3 Volt Intel[®] Advanced+ Boot Block Flash Memory

28F800C3, 28F160C3, 28F320C3, 28F640C3

Specification Update

Order Number: 297938-014

2. 28F320C3xC Reset Failure

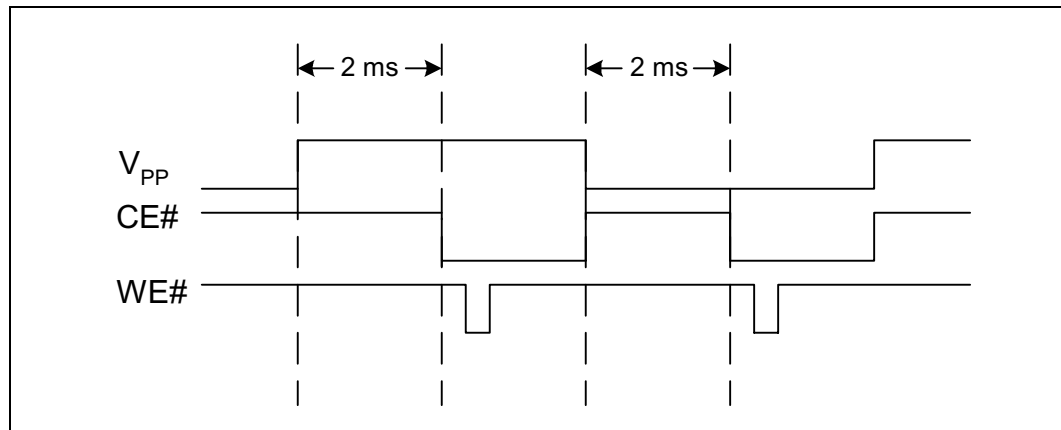
Problem: The 0.18 μ m 28F320C3xC devices can unintentionally reset under certain conditions where V_{pp} toggles.

Implication: When the reset occurs, any command being executed is interrupted and the flash switches to read array mode.

- 1) Tie V_{pp} to V_{CC} ;
- 2) If the third and fourth digits on the top side FPO mark (third line) is equal or greater than “23”, then V_{CC} may be set from 2.7v to 3.3v. V_{CC} must not exceed 3.3v
- 3) Set V_{pp} to a static high or static low level as shown here; and

4) Wait 2 ms after a V_{PP} transition to access the flash device, as shown here.

Figure 1. Workaround Placement

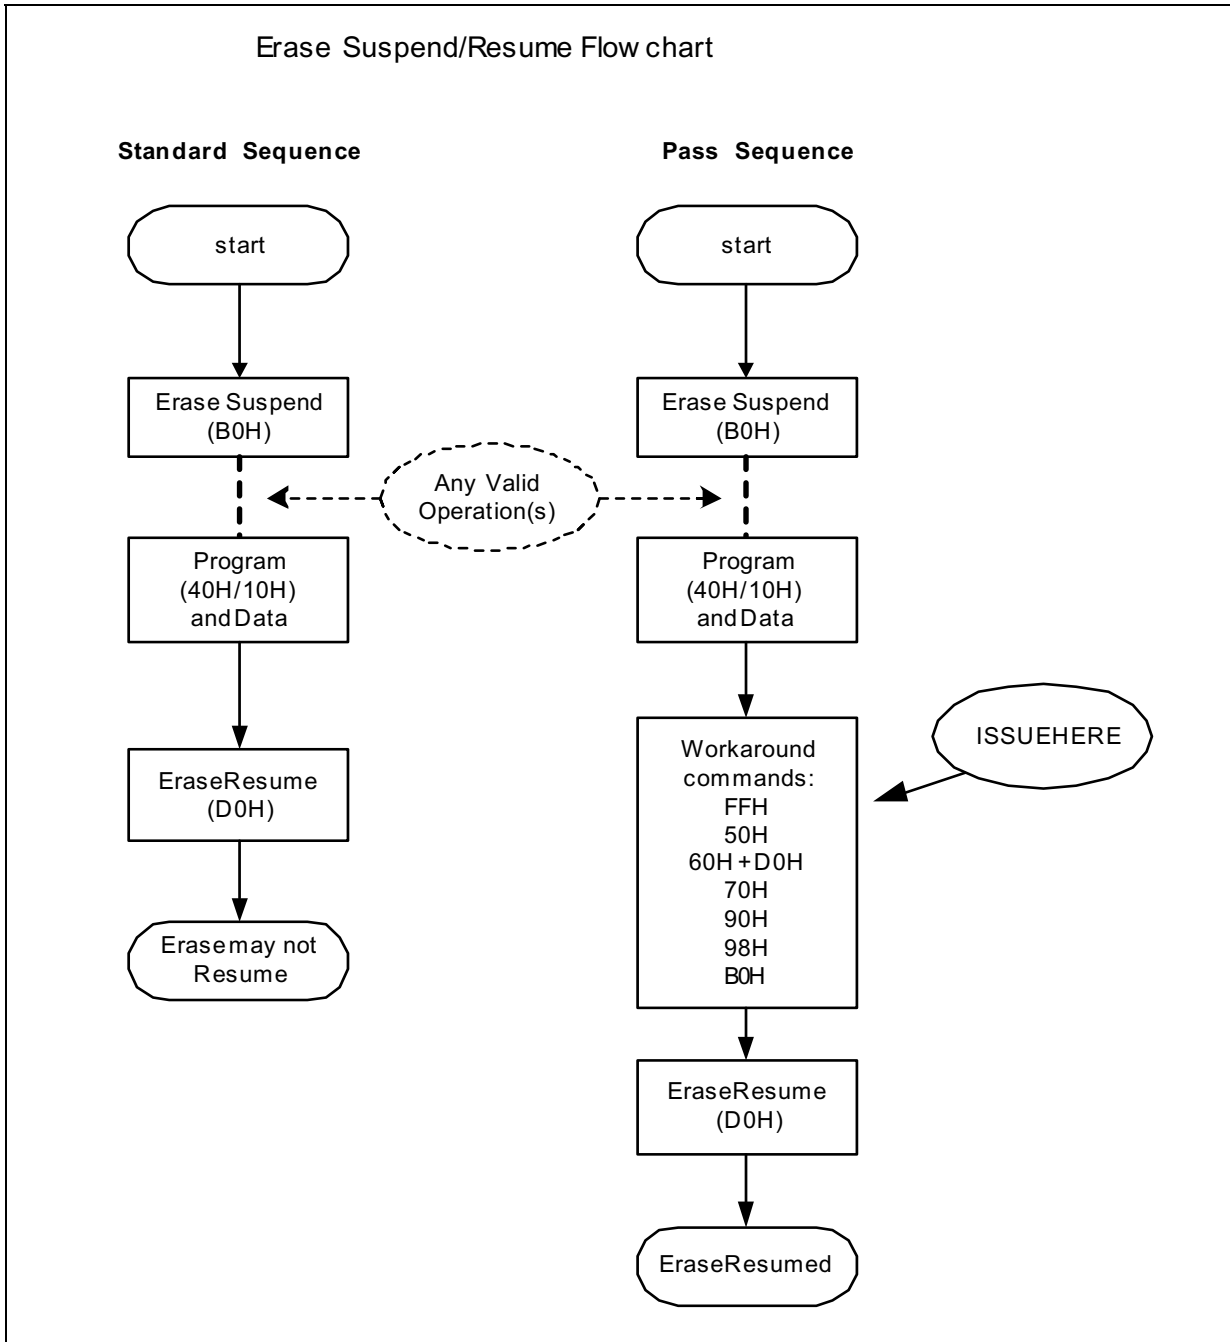
Problem: On the 0.18µm 28F160C3xC devices, a design anomaly was discovered. During an Erase-Suspend operation, if the Program (40H/10H) sequence is executed, under limited conditions the proceeding Erase Resume command (D0H) may not actually resume the device. No customers have reported failures in product applications. Customers who use any version of FDI (Intel Flash Data Integrator) software will not see this issue. If the Read Array command is issued prior to the Erase Resume command, users will not see the issue (typical in XIP applications).

Implication: The Resume Command (D0H) may be ignored by the device and will not correctly resume. The device will appear to remain in suspend (via status register). After a reset of the flash device the status register will clear. This failure has been recreated in a lab environment only.

1. If FDI (Intel Flash Data Integrator) software is used, users will not see the issue.
2. During an Erase-Suspend (B0H), user must issue any of the following commands after issuing the Program (40H/10H) and data sequence but before issuing the Erase-Resume (D0H) command.

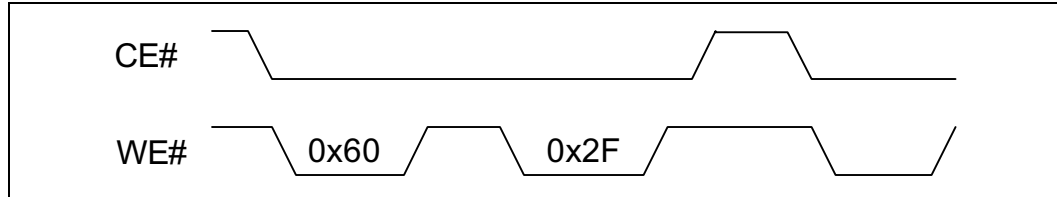
Problem: On the 16Mb and 64Mb 0.18µm devices, if CE# is deasserted after any block lock operation and before the next write sequence, the part may perform the same operation on additional blocks. (See waveform below.)

Implication: When CE# is deasserted after performing a block lock operation to a specific block and prior to the next write sequence, other blocks may perform the same operation.

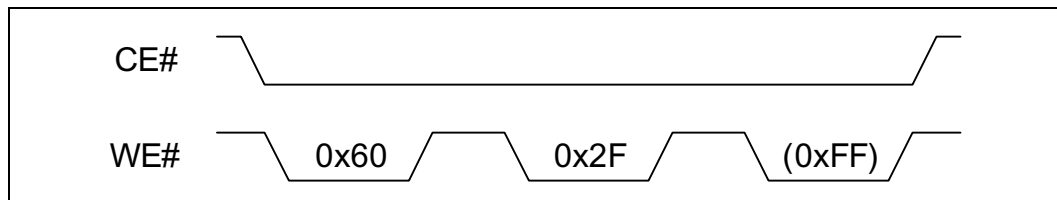
Immediately after performing a block lock, unlock, or lock-down operation, perform a valid write sequence before chip enable (CE#) is deasserted.

For example, one possible solution is shown below:

- 1) Assert CE# and toggle WE# to write the block lock setup command (0x60).
- 2) Toggle WE# a second time to write the confirm command (lock = 0x01; unlock = 0xD0; lock-down = 0x2F).
- 3) Toggle WE# a third time (ex: 0xFF- Read Array) before CE# is deasserted. (See waveform below.) Any other valid write sequence will also work (i.e., 0x90 - Read Configuration, 0x40 - Program, 0x20 - Erase).
